SEWAGE DISPOSAL SYSTEM

MARYLAND STATE DEPARTMENT OF HEALTH

A Repair

NOT APPROVED

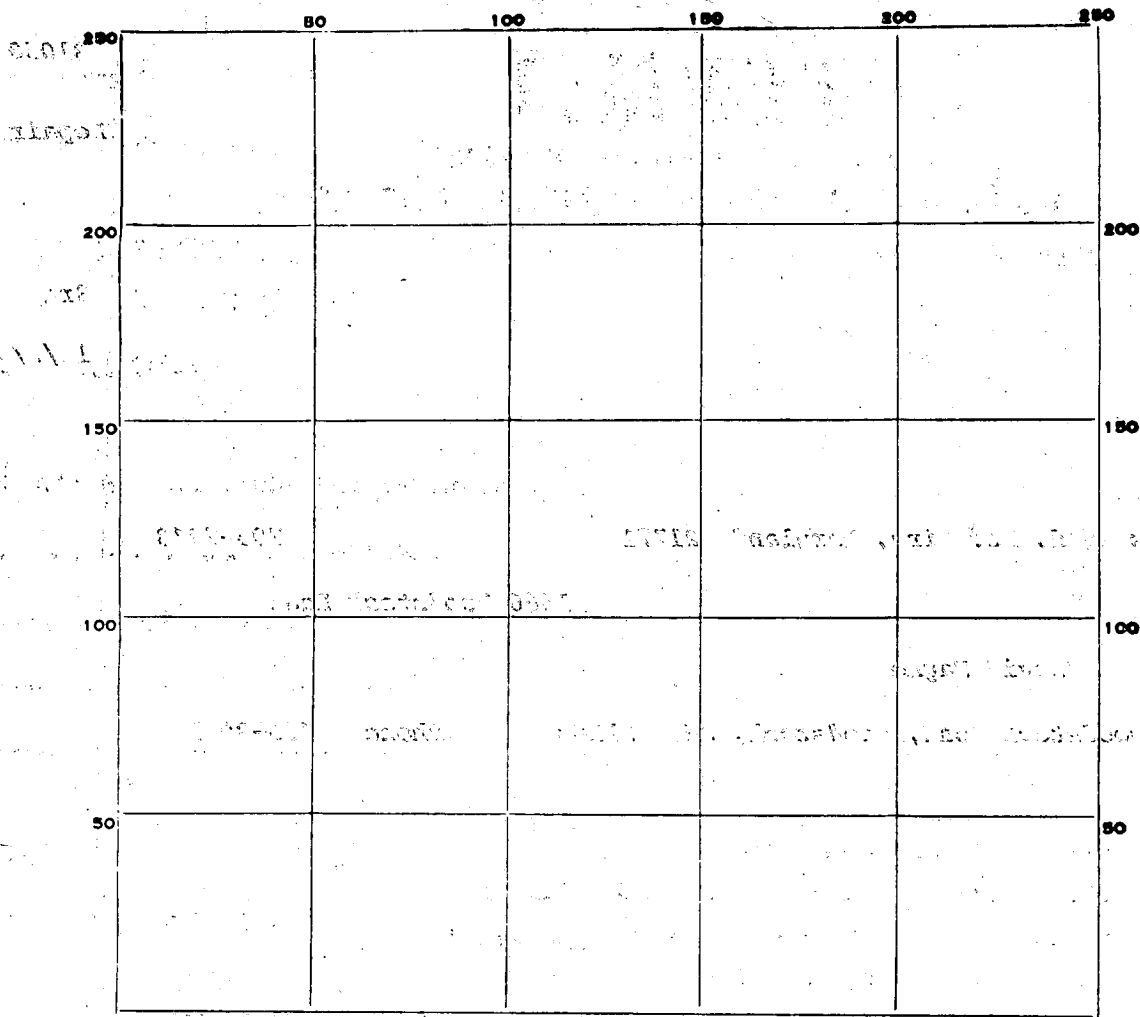
REPAIR - Call for an appointment when ground is opened up and Sanitarian will recommend the repair system.

Then The House. I told Mrs Mayne that it would probably fail the perc test. She wants to put in a sealed tank if it fails the perc. There are two sealed tanks across the street: one for the Woodstock Inn & one for a house owned by Carey rented by Plat

12/17/80 - No Sealed Tank allowed per FS

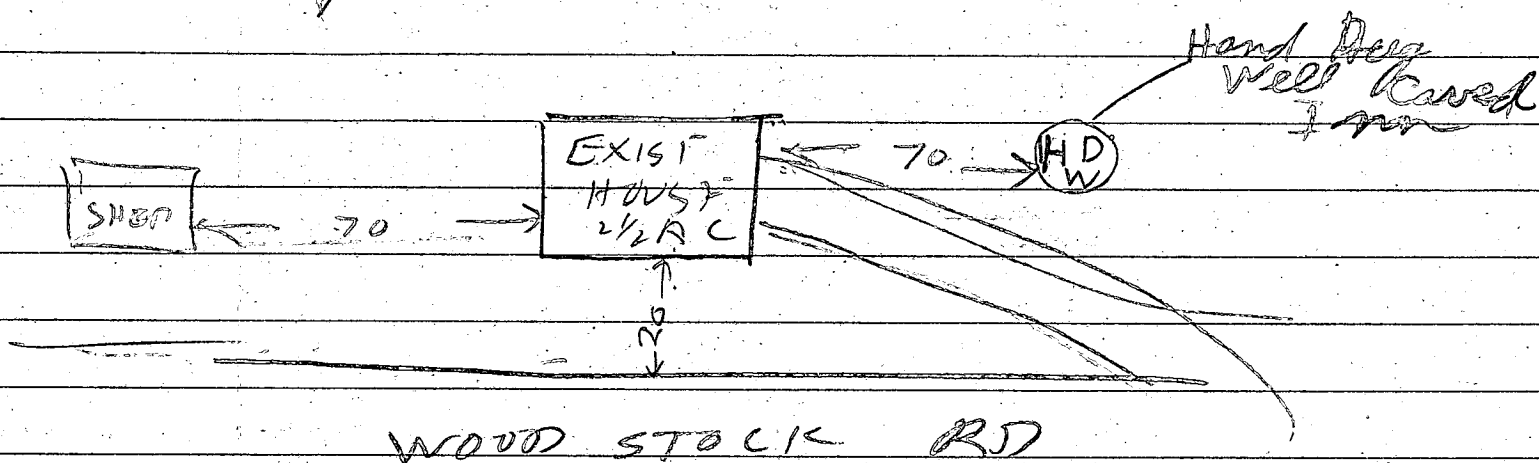
PROPERTY BOUNDARIES NOT KNOWN. (200-300') CONSIDERABLE LAND AROUND HOUSE.

ALL APPEARS TOO STEEP FOR WELL OR SEPTIC EXCEPT AREA TO LEFT OF HOUSE WHICH HAS ROCK OUTCROP.

2ND STORY ADDITION ON BACK OF HOUSE, POORLY SUPPORTED. NO PERMIT.

EXISTING PRIVY & HAND DUG WELL IN DISREPAIR. CW,

VERY STEEP
SLOPE

12/15/80 - Visited Site Talked to Bud Arnold
& Mrs Mayme. Bud Arnold did not dig
any holes. House has no septic system
& no well. Hand Dug well Covered. They want both. Grounds is sandy Rocky
with steep slope left in back yard. 2 1/2
ac lot with only a little area on the sides
& in front of the house, that is lower
OVER
